# WESTERN CLAY COMPANY

Re: Review of large mining plan notice of intention, Western Clay Company, Hebe Gypsum Mine, M/015/0172 (UTU-73779), Emery County, Utah

This letter is drafted to provide further information requested by the division in your letter of June, 6 1997. Our responses are formatted in the same manner as that letter to facilitate comparisons.

## X-SECTION B-B'

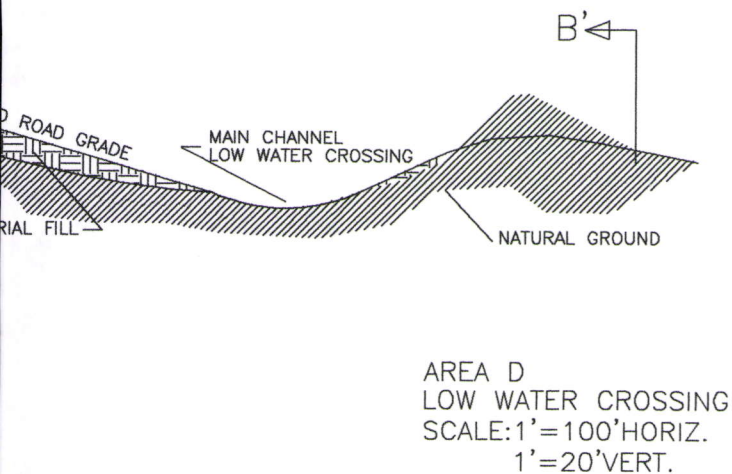
## **105.2 Surface Facilities Map**

The map intended to be our surface facilities map was titled "Plan of Operations 1997-2008 Hebe Mining Claims".

A copy of a revised map showing stream crossings and cross sections is enclosed with this letter.
